Agenda
Village of Arlington Heights
Design Commission
Community Room, 3rd Floor

Arlington Heights Village Hall
33 S. Arlington Heights Road
Arlington Heights, IL 60005
August 8, 2017
6:30 PM

MINUTES OF
THE VILLAGE OF ARLINGTON HEIGHTS
DESIGN COMMISSION MEETING
HELD AT THE ARLINGTON HEIGHTS MUNICIPAL BUILDING
33 S. ARLINGTON HEIGHTS RD.
JULY 11, 2017

EXTERIOR ELEVATIONS

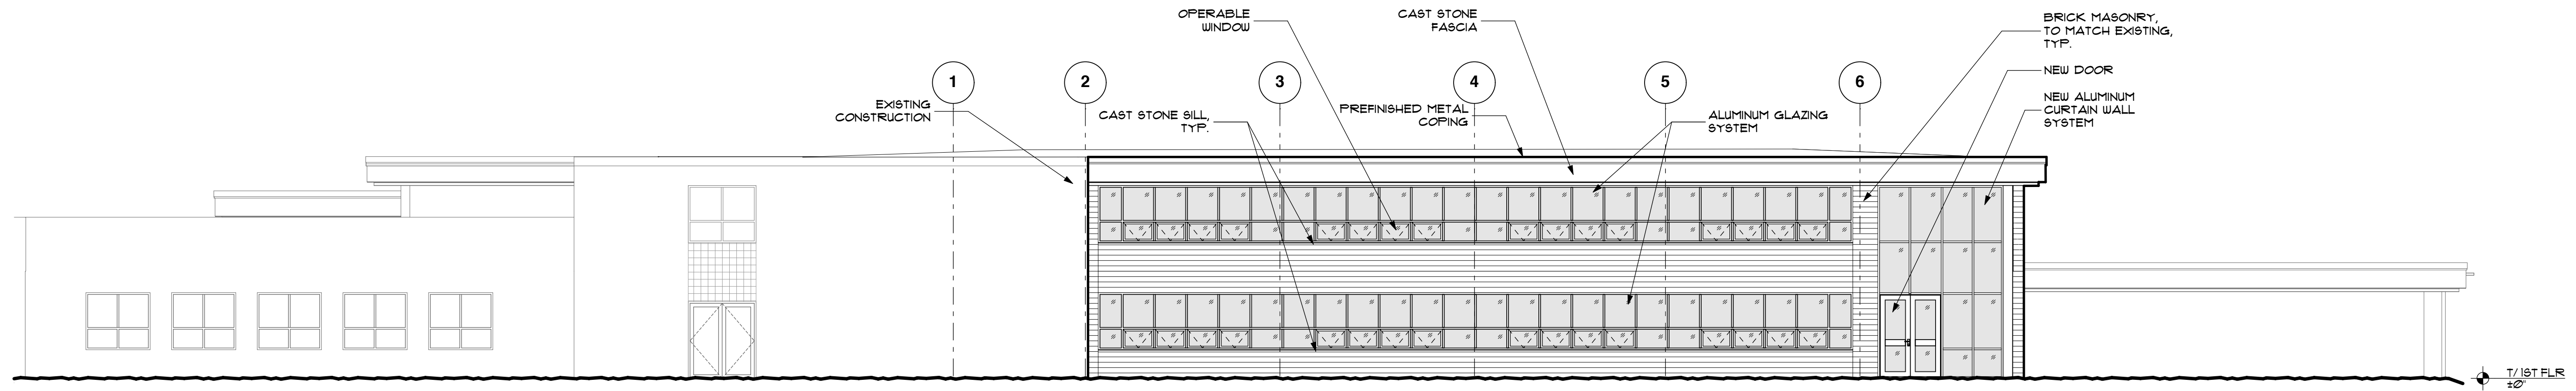
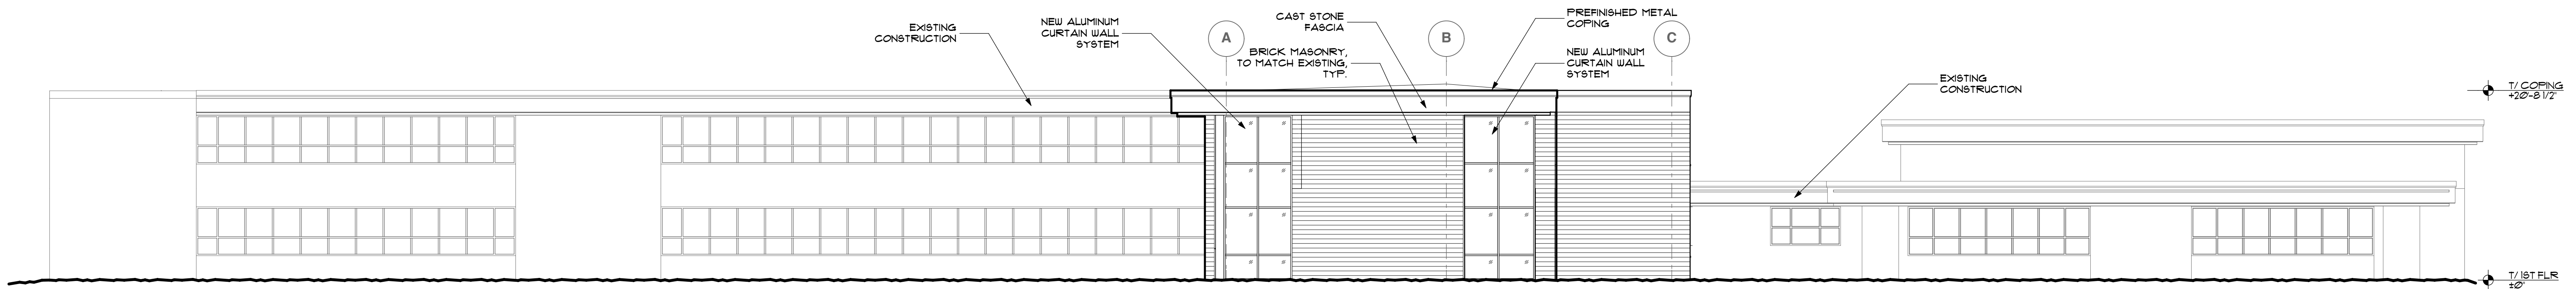
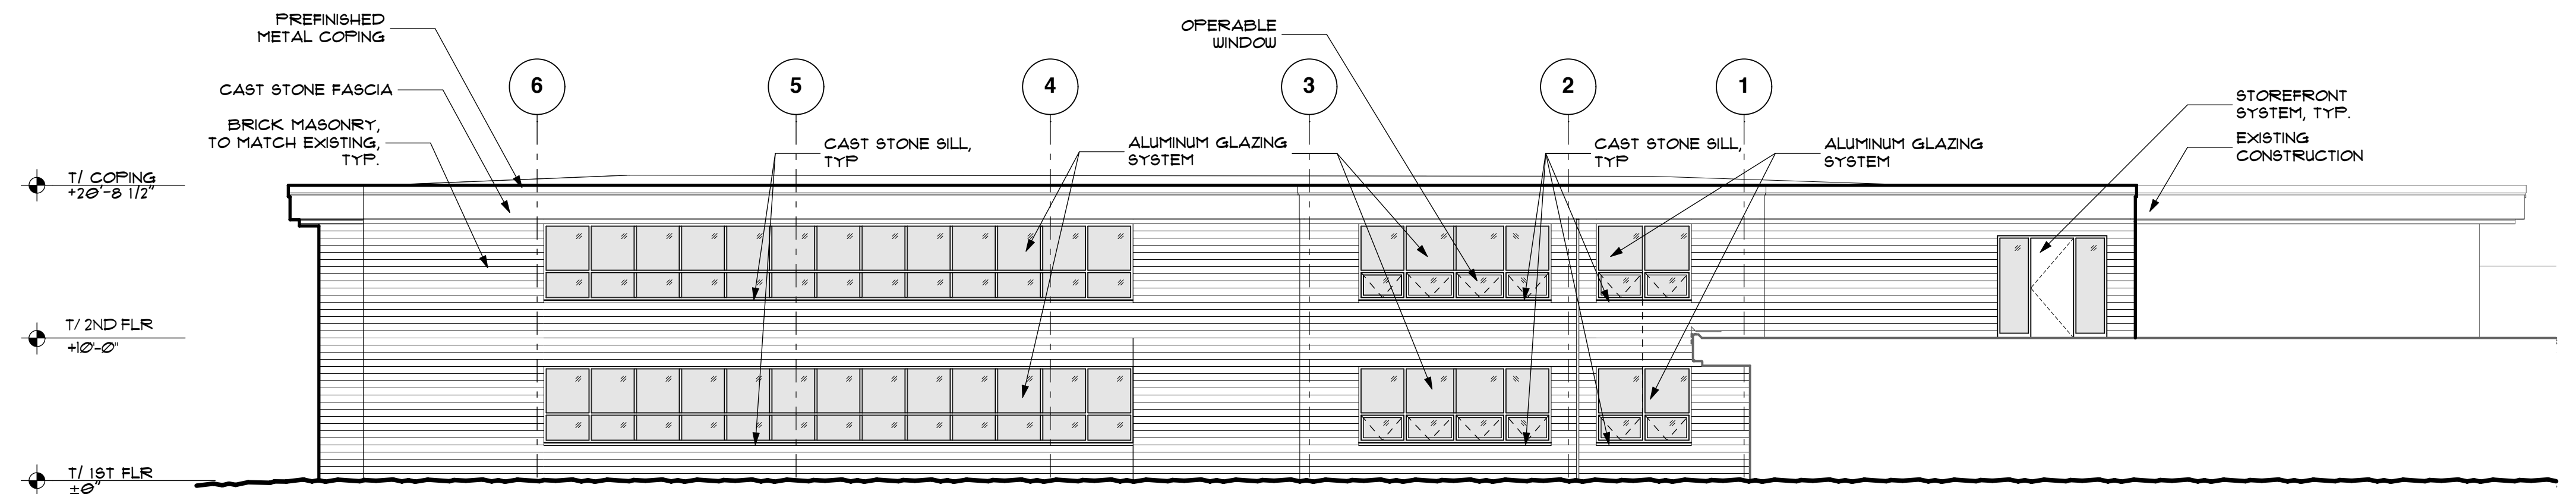
1. Provide foundation plantings including a mix of shrubs and perennials a dark bronze metal coping at the top of the brick walls to match the existing building.

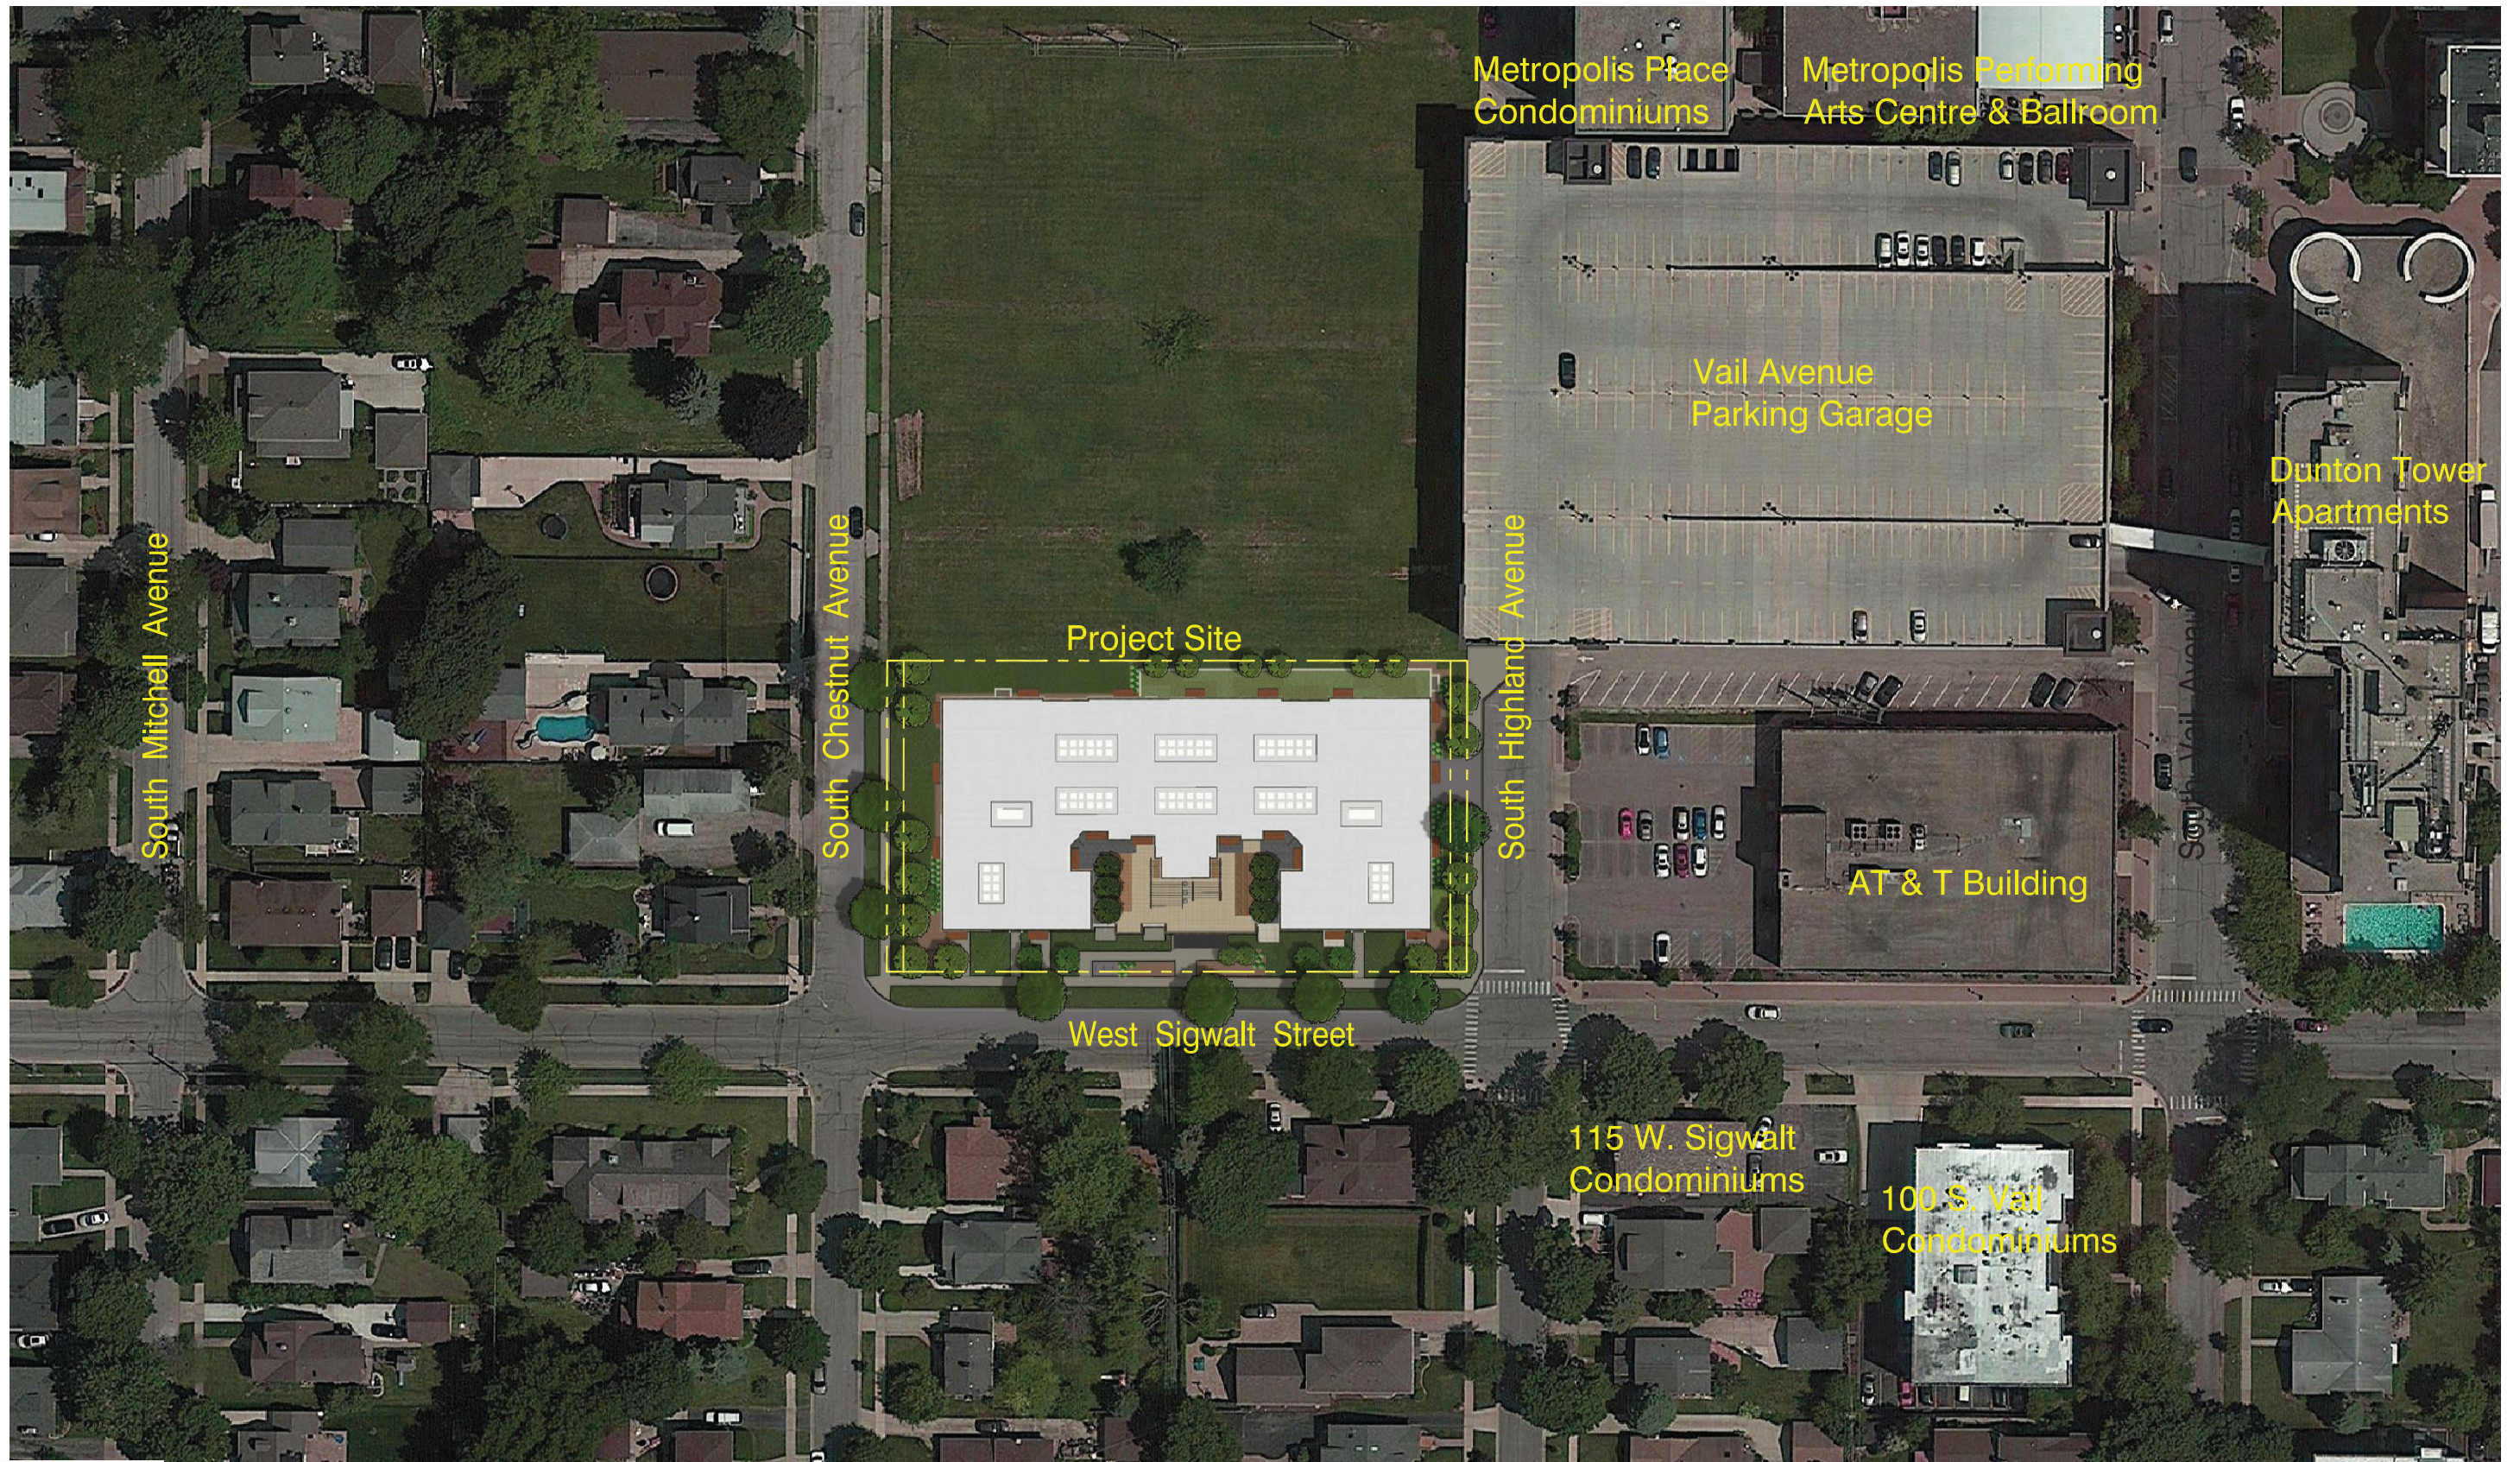
1. Evaluate the quantity and color of metal panel siding.
2. If possible, consider lowering the height of the top floor walls one or two feet.
3. Consider stepping back portions of the top floor to break down the overall mass of the building, such as recessing balconies at the outside corners.
